## **WINDHAM STREET SIDEWALK IMPROVEMENTS**

Project: BI-RW-326

### **ADDENDUM NUMBER 1**

Date of Addendum: February 18, 2014

**SECTION A-A**  
WITH 6" CONCRETE CURB REVEAL

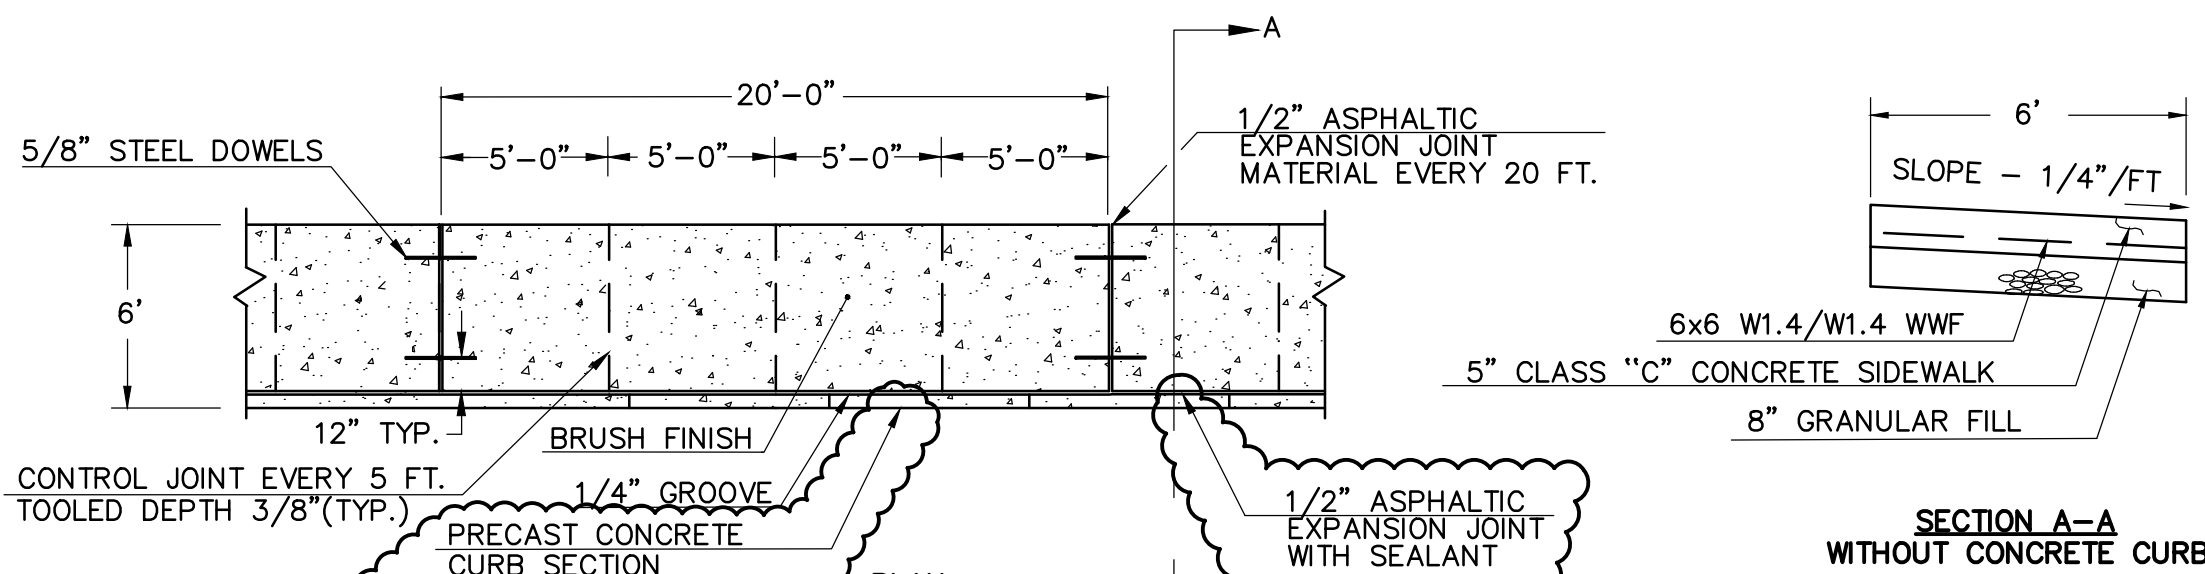
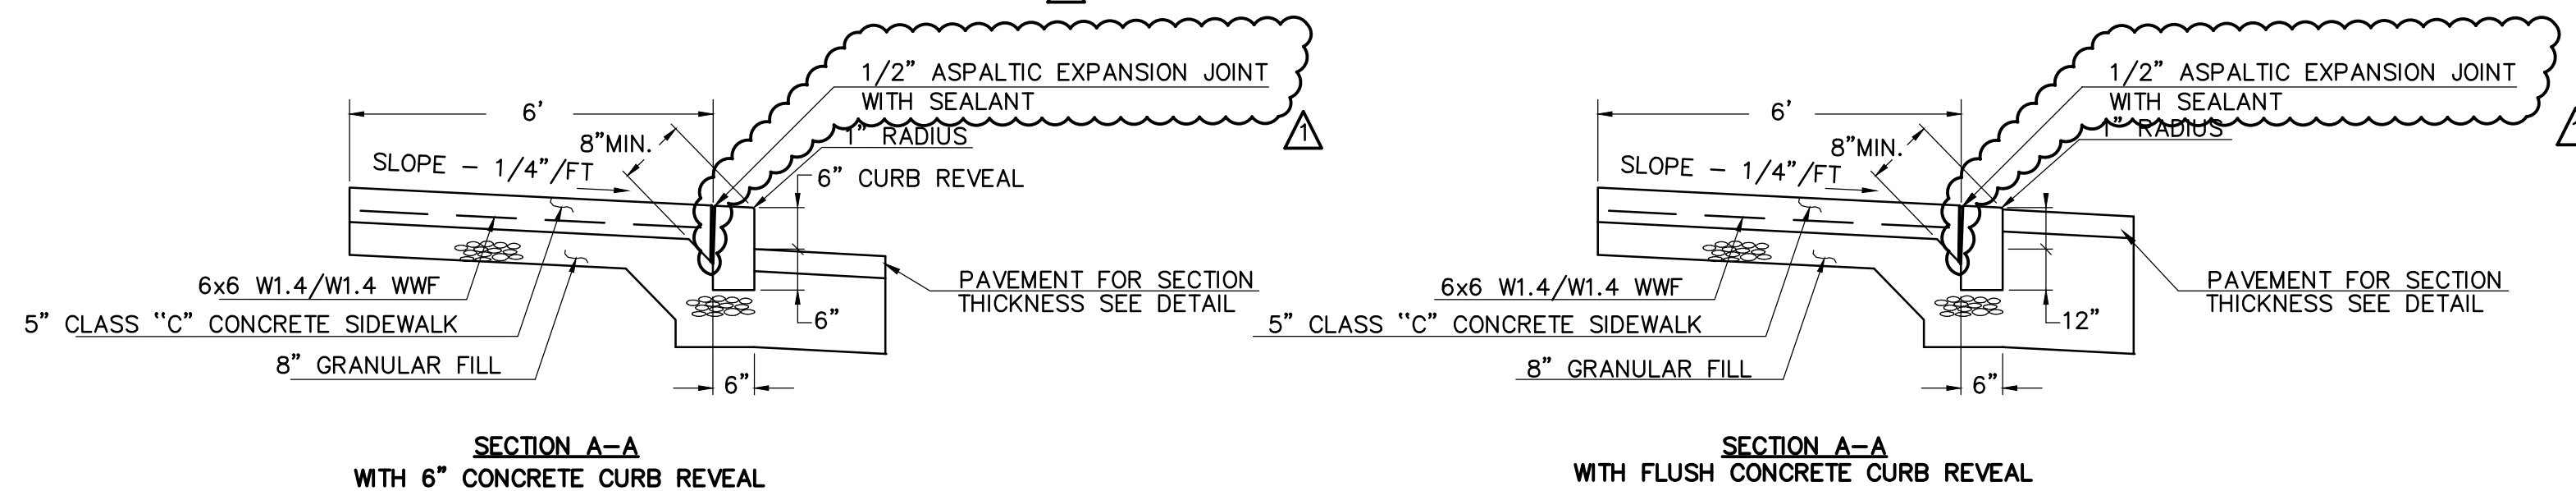
RFI #1: The drawing has two sidewalk curb details one with a monolithic pour and one with a precast concrete curb. What type of curbing are we doing? From: Pazz Construction on 2/5/2014

Eastern Response: Curbing shall be precast concrete. Please see the revised drawing sheet C2.00.

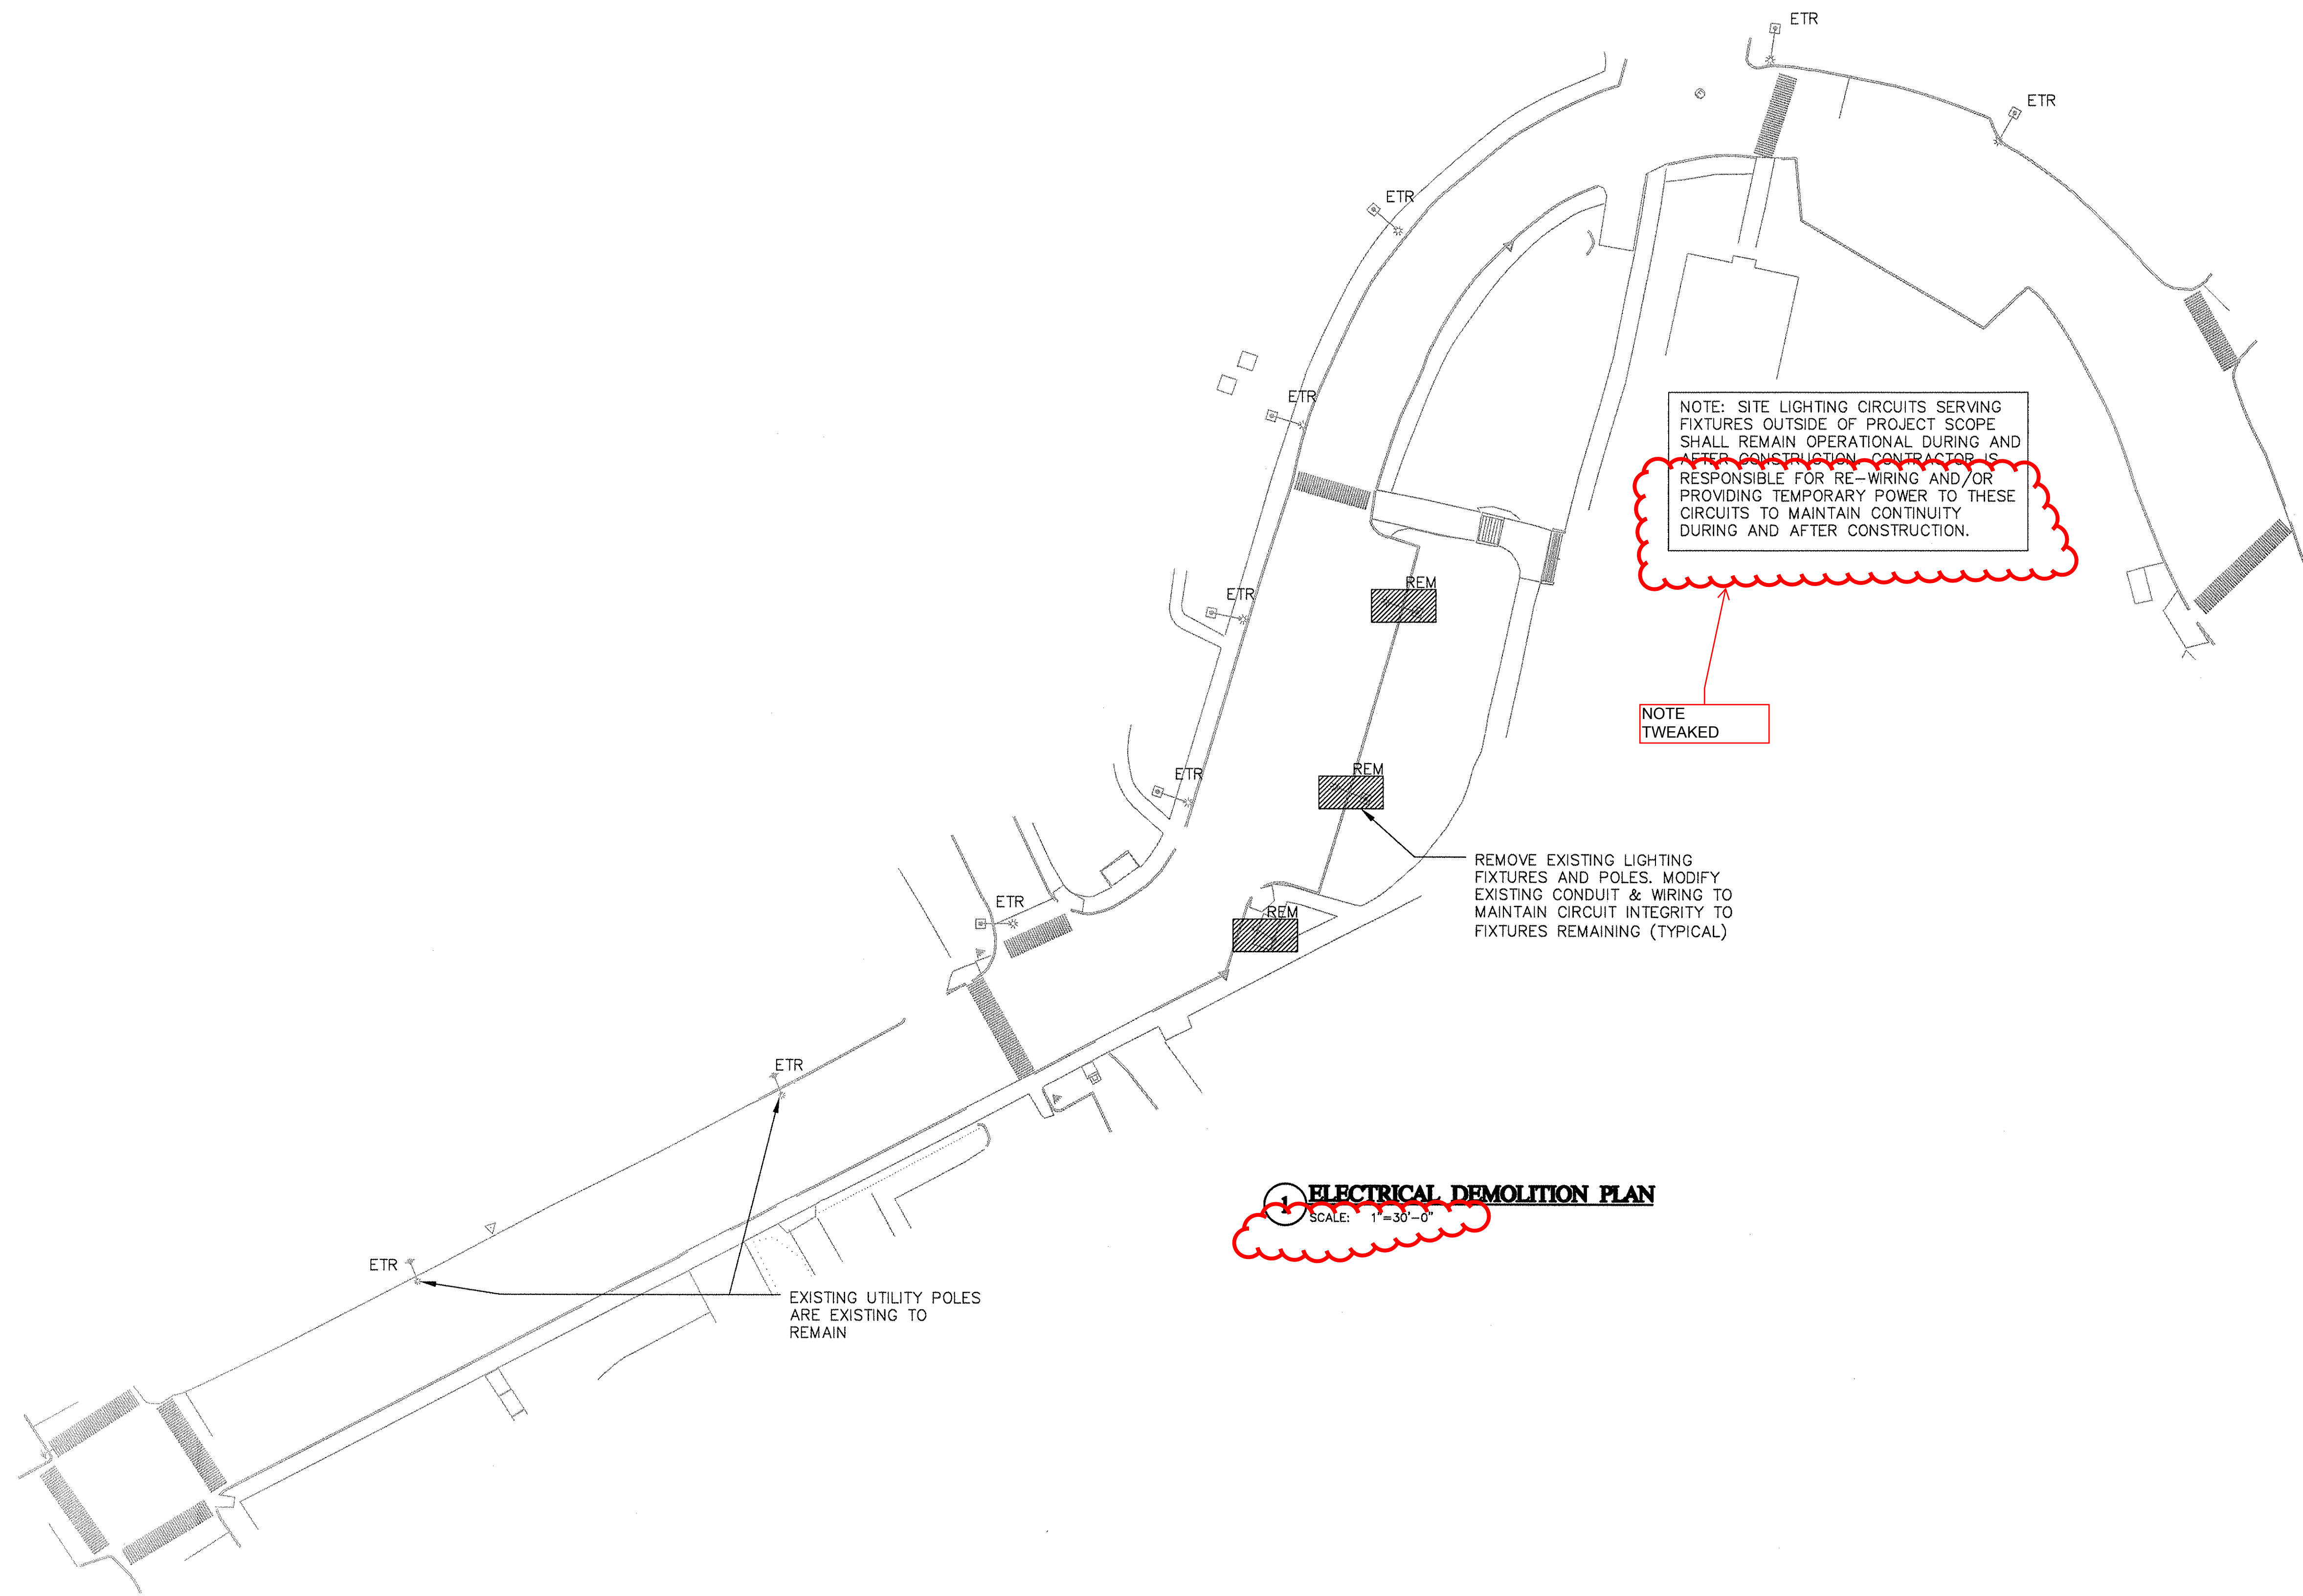
ITEM 3: Delete drawing sheet C2.00, E.100, and ED1.00 from the construction drawings and substitute with the attached drawing C2.00, E1.00, and ED1.00 respectively. Please see revision clouds on the updated drawings which highlight the changes.

NOTE: SITE LIGHTING CIRCUITS SERVING FIXTURES OUTSIDE OF PROJECT SCOPE SHALL REMAIN OPERATIONAL DURING AND AFTER CONSTRUCTION. CONTRACTOR IS RESPONSIBLE FOR RE-WIRING AND/OR PROVIDING TEMPORARY POWER TO THESE CIRCUITS TO MAINTAIN CONTINUITY DURING AND AFTER CONSTRUCTION.

NOTE TWEAKED
